Subject: Mt. Carmel Grove City Medical Center  
Development plan Amendment Application  
Control No.: 201603110014  
EMH&T Job No.: 2013-1538

We have summarized the comments received from City of Grove City on March 23, 2016 and provided our response. The plans have been updated to address the comments as follows:

MOUNT CARMEL  
Grove City  
Phase II  
Development Plan

**L-1.4**

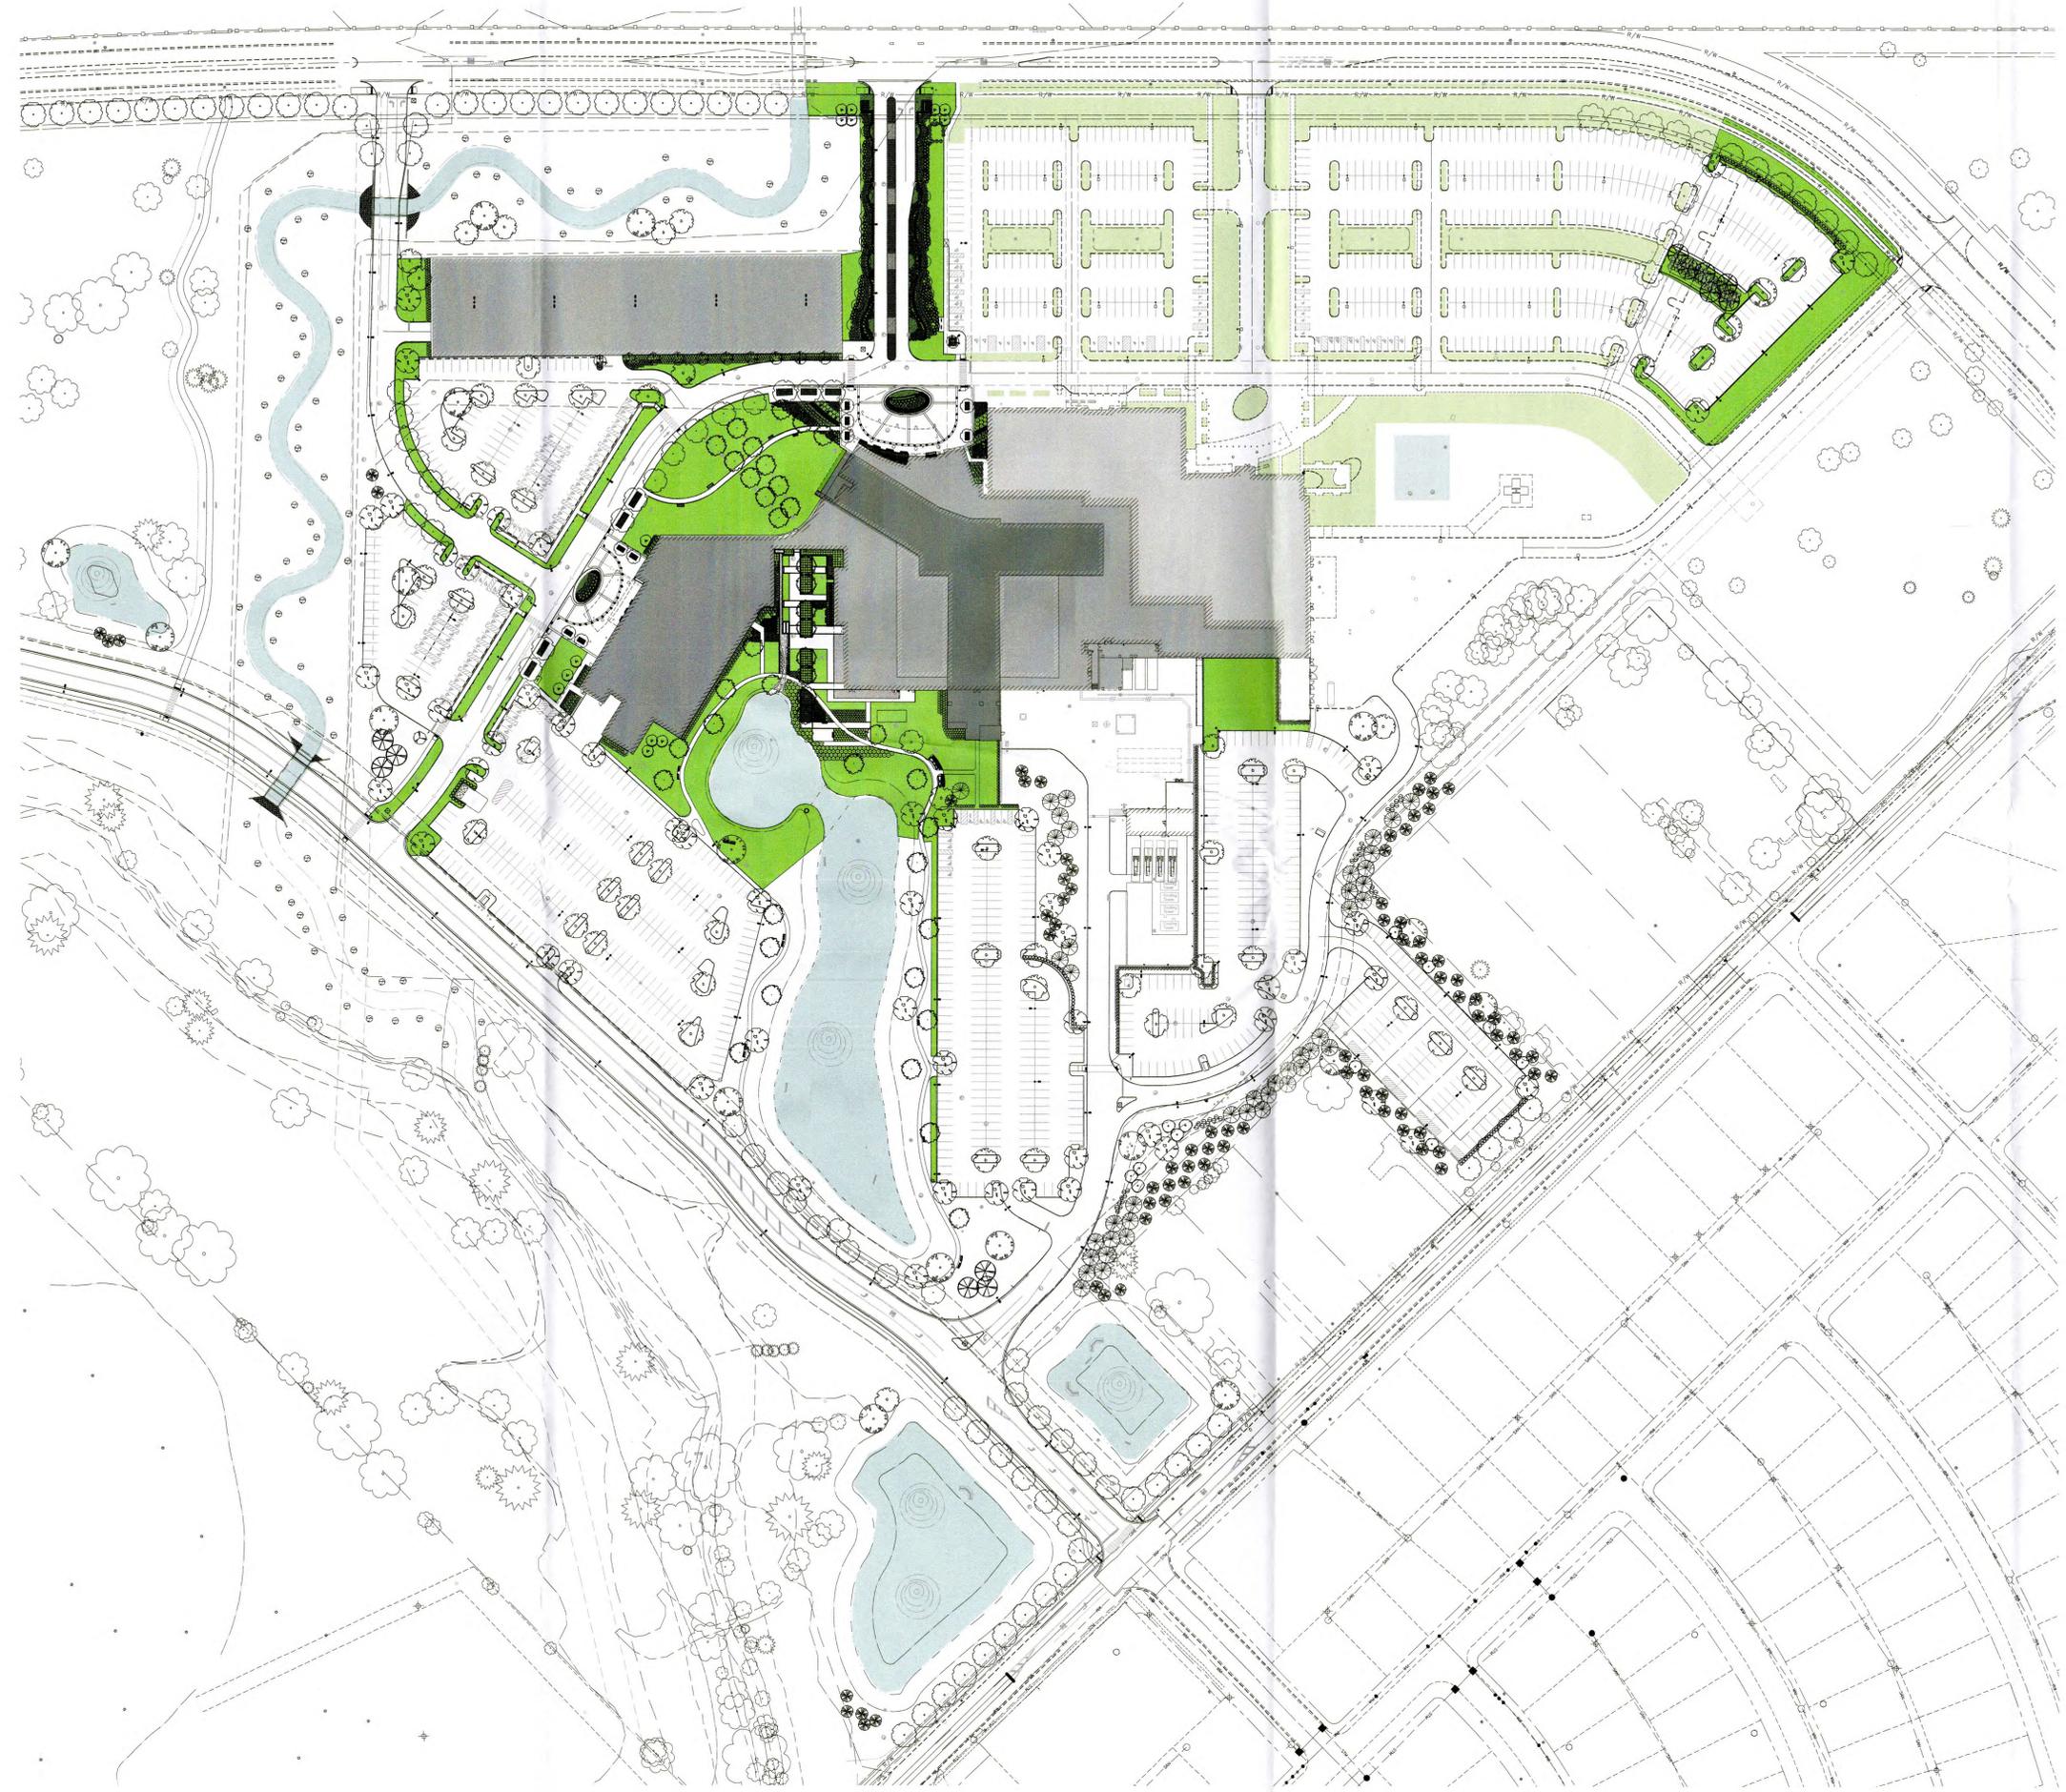
10. I do not support the proposed variances on sheet L-1.4. Irrigation should be per code section 1136.09(a)(3).

**Response: The Owner would prefer to maintain the irrigation configuration as shown, concentrated around the proposed building improvements and major view corridors. Landscape plantings proposed by the LA for the Hoover Road lot were selected based on no irrigation serving the parking lot.**
